RAMSEY WATER TREATMENT PLANT
 CITY OF RAMSEY
 RAMSEY, MN
 RESERVOIR ROOF PLAN AND ELEVATIONS

RAMSEY WATER TREATMENT PLANT
 CITY OF RAMSEY
 RAMSEY, MINNESOTA

RAMSEY WATER TREATMENT PLANT
 CITY OF RAMSEY
 RAMSEY, MINNESOTA
 SITE PLAN

DRAWING
A110

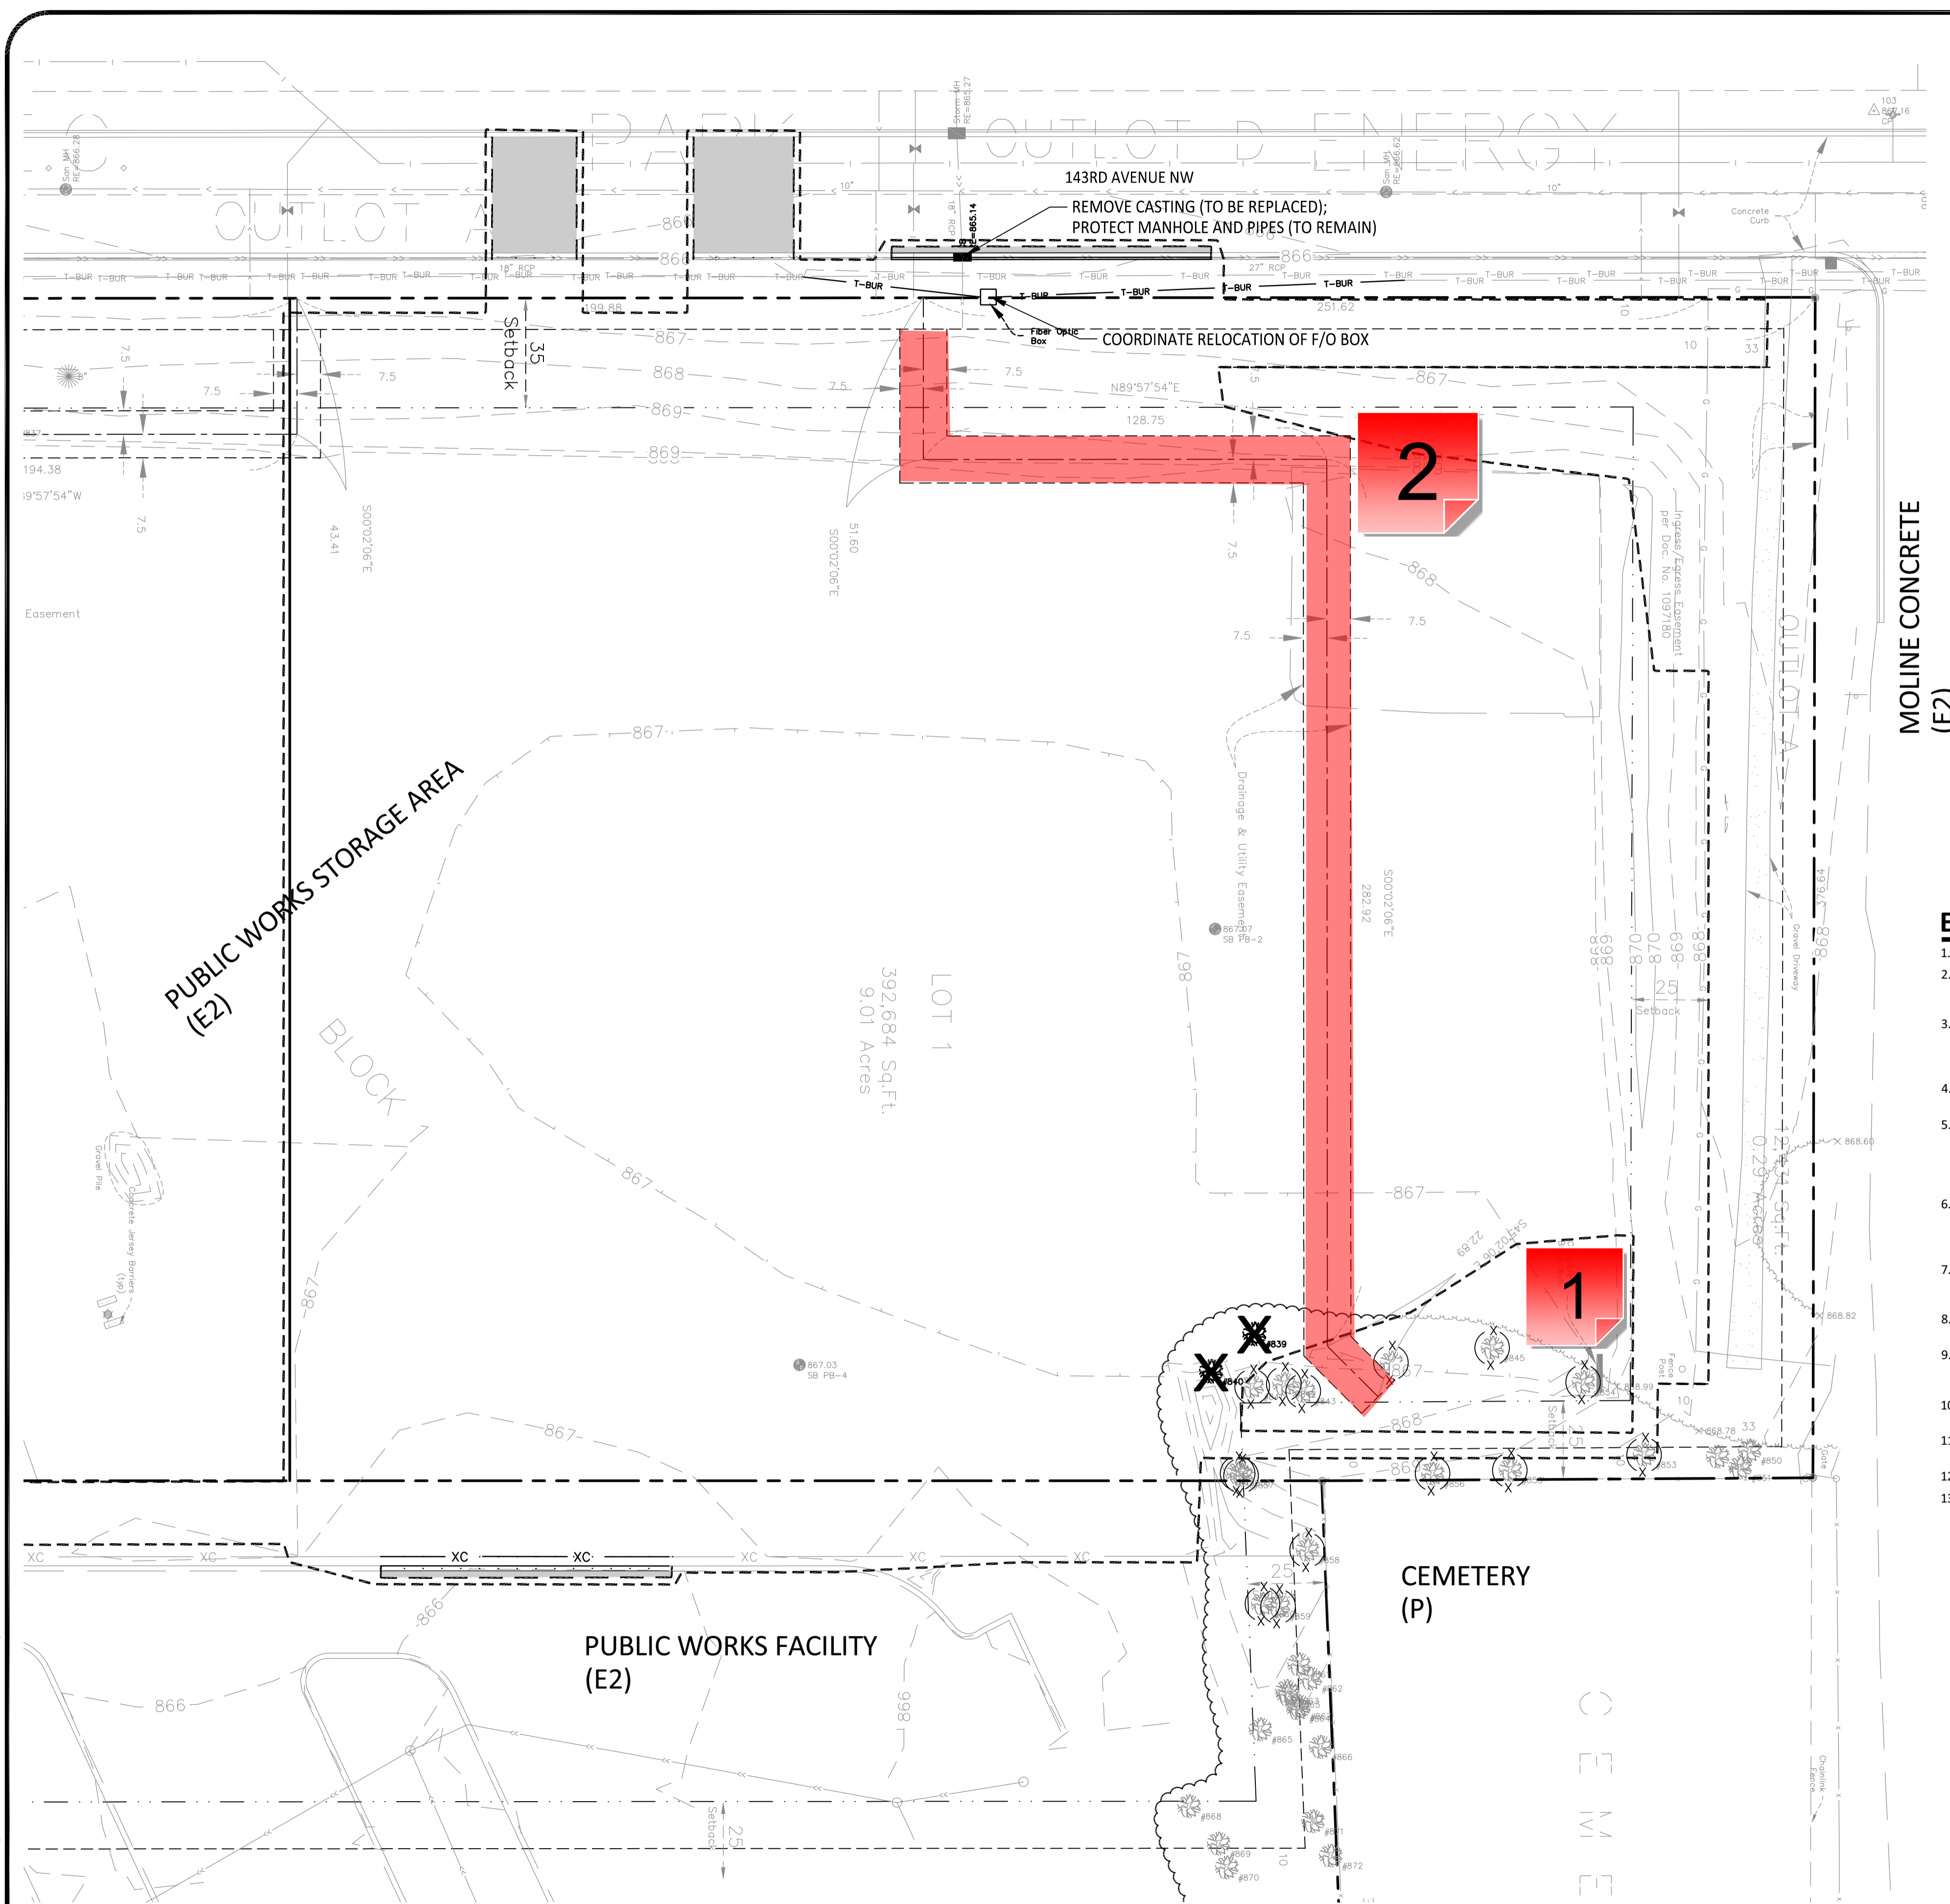
A Permanent Sign Permit will be required for the proposed signage. Please have sign contractor provide schematic drawing, including dimensions, and application for review.

DRAWING
C100

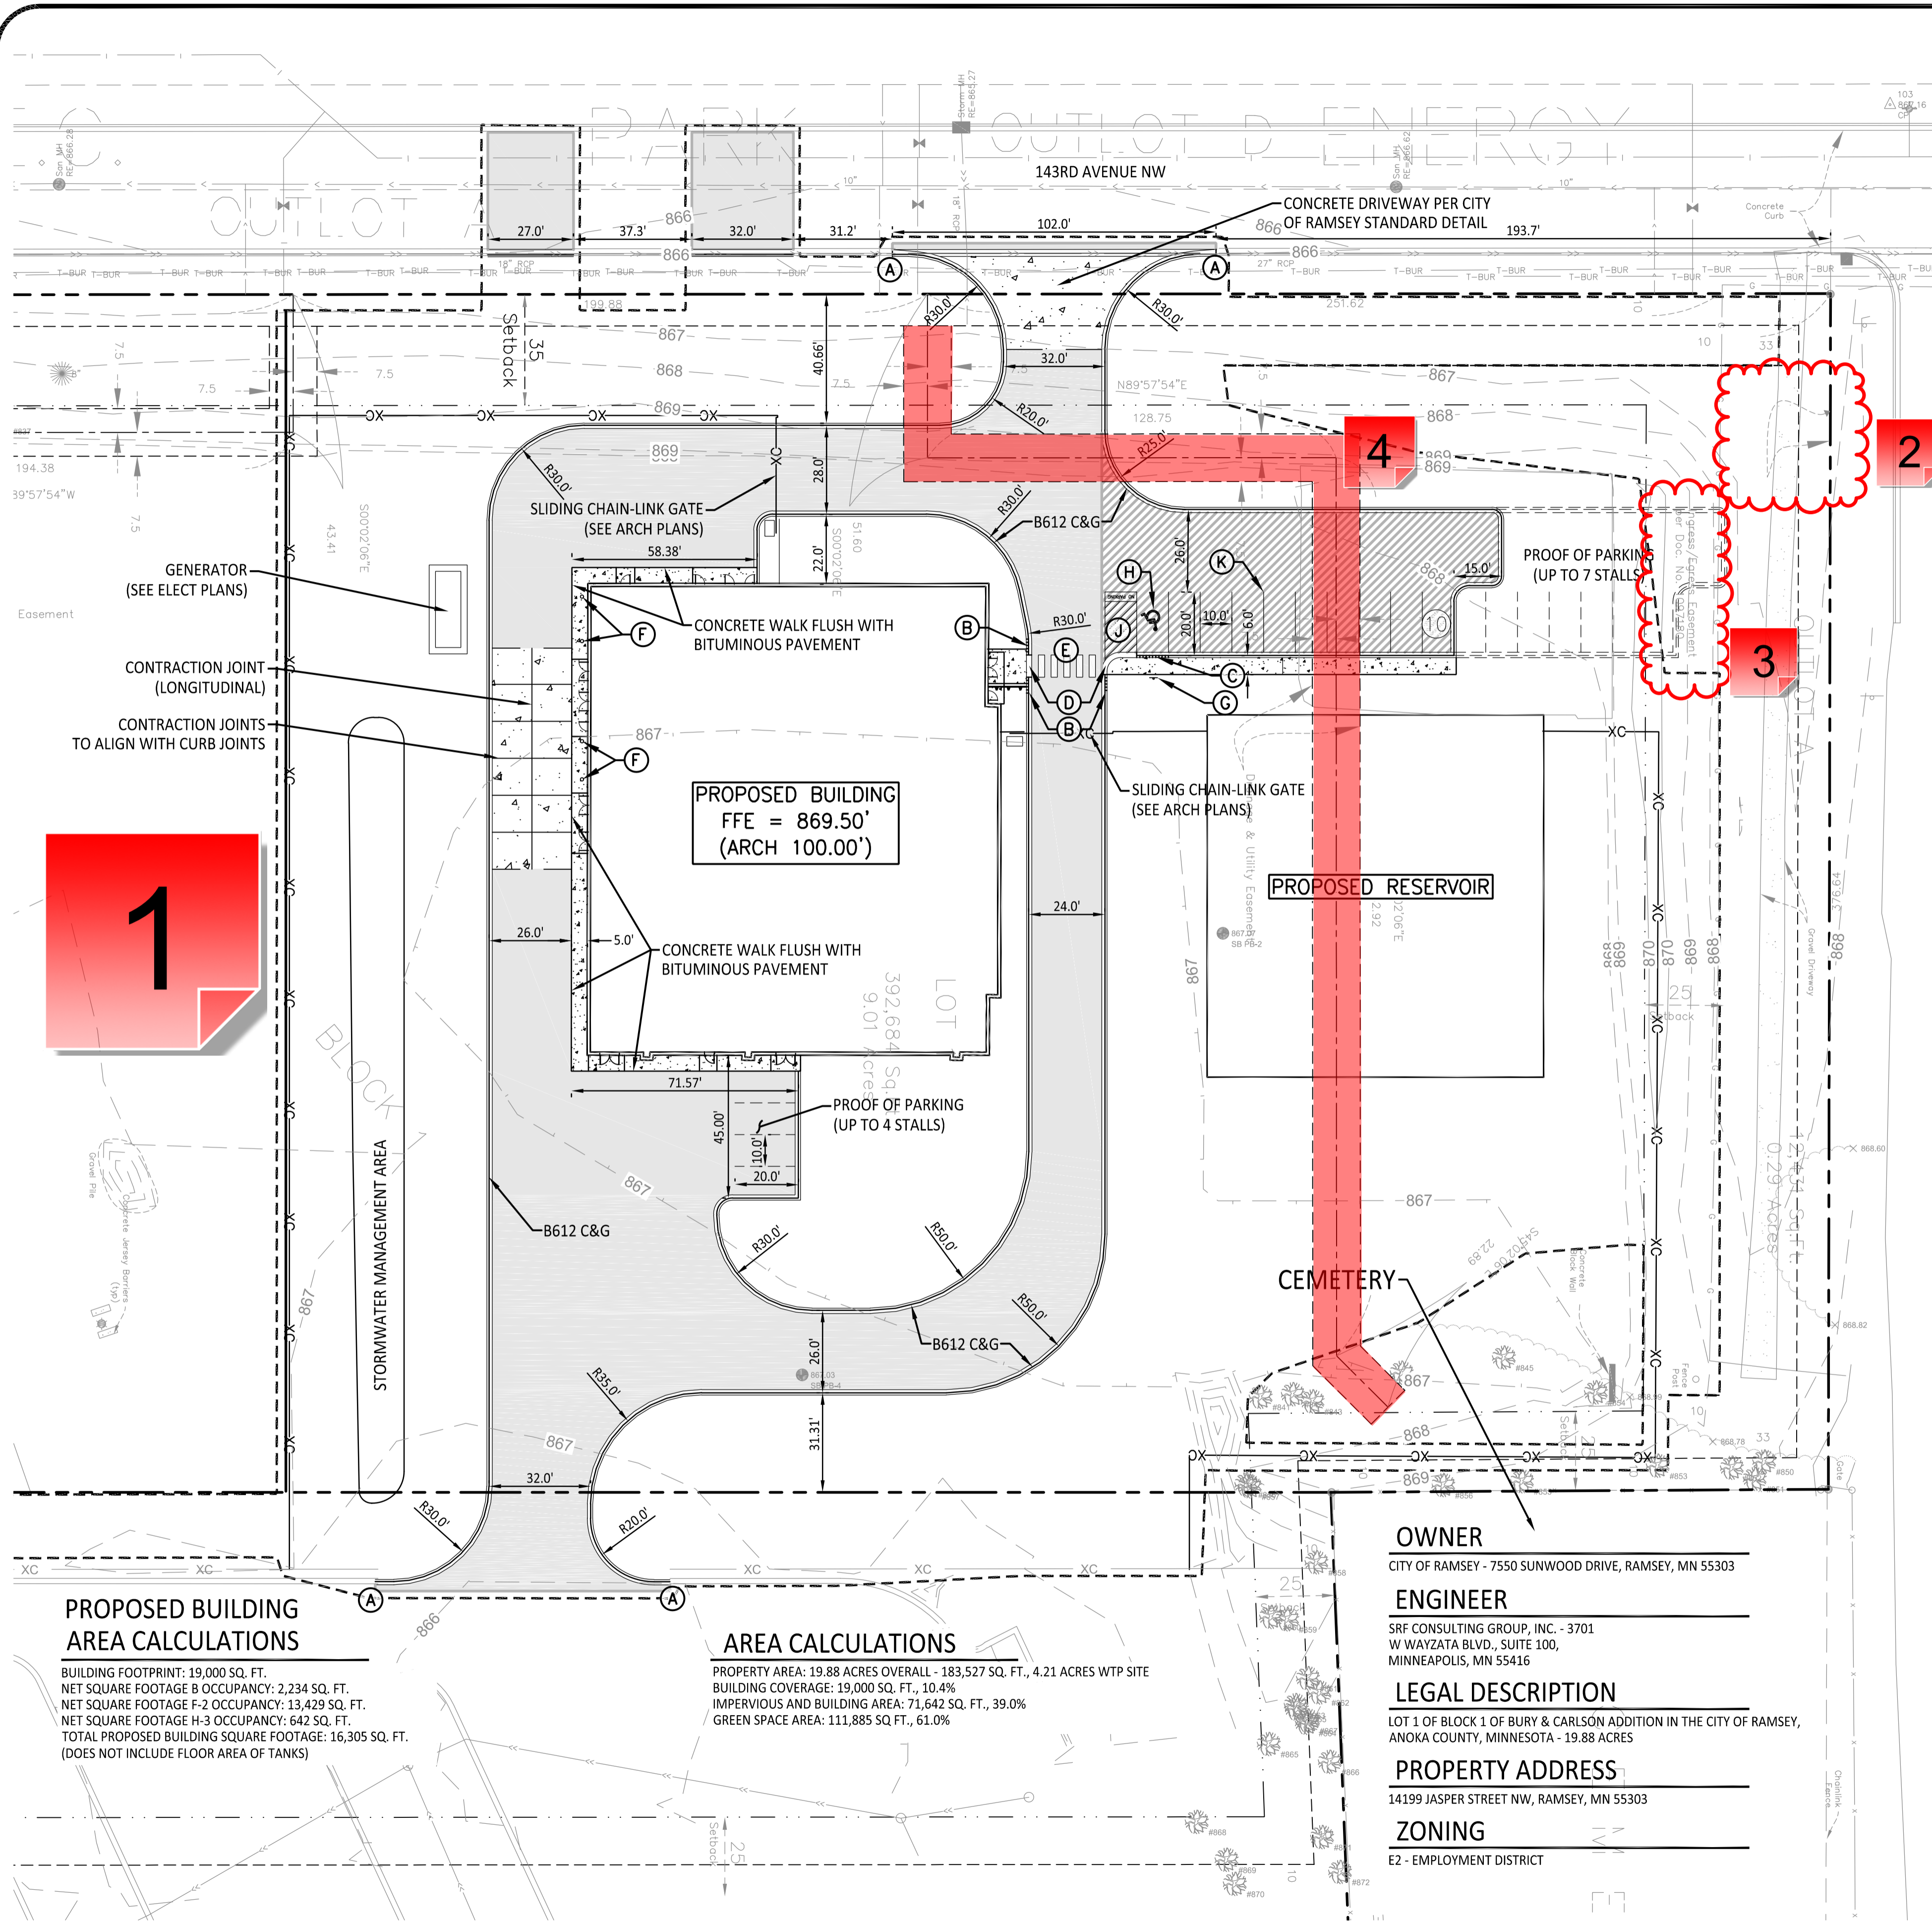
These trees appear to be siberian elm and black locust, both of which are considered invasive species. These should be removed, and the area should be established with mesic seed mix and more desirable tree species.

Is this easement still necessary? If not, please prepare an exhibit and legal description and the city will initiate the easement vacation process.

DRAWING
C200

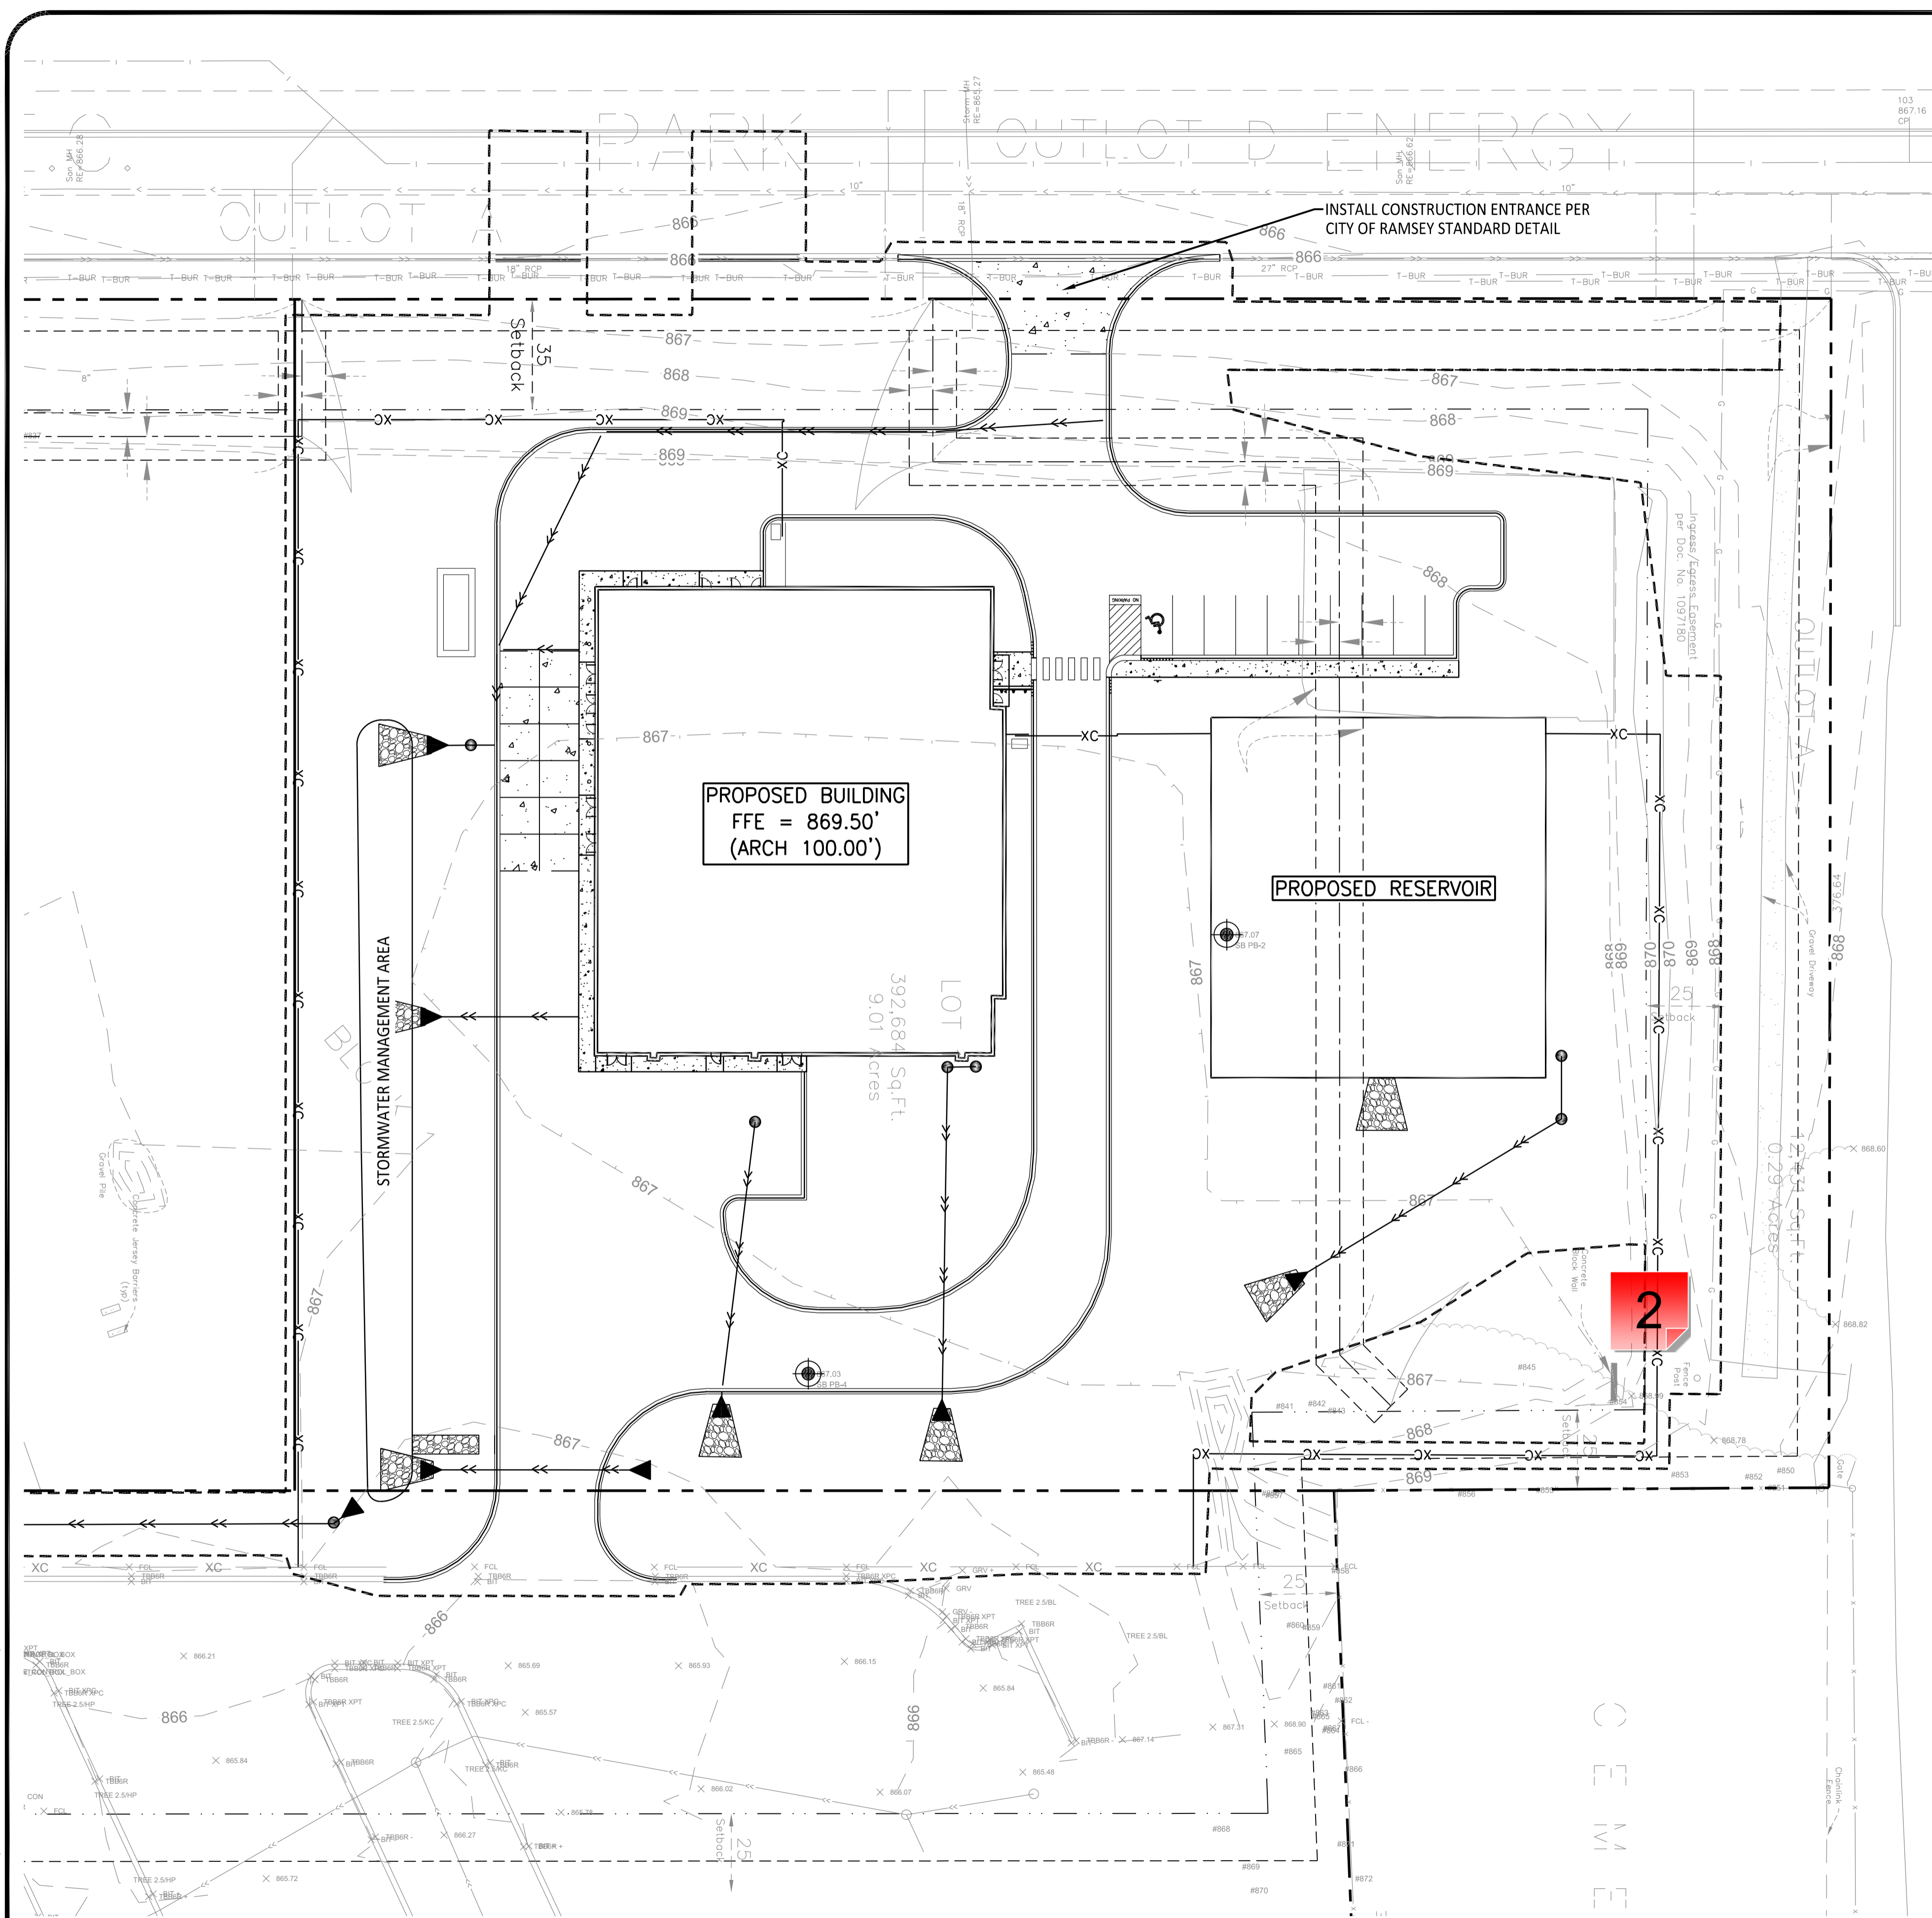
A plat is required to create this lot. Please submit.

Show this easement on the Site Plan. Recommend that it get platted as separate outlot.

What is the purpose of this d/u easement and is it needed any more? If not, an exhibit should be prepared, including legal description, and this should be vacated as part of this process.
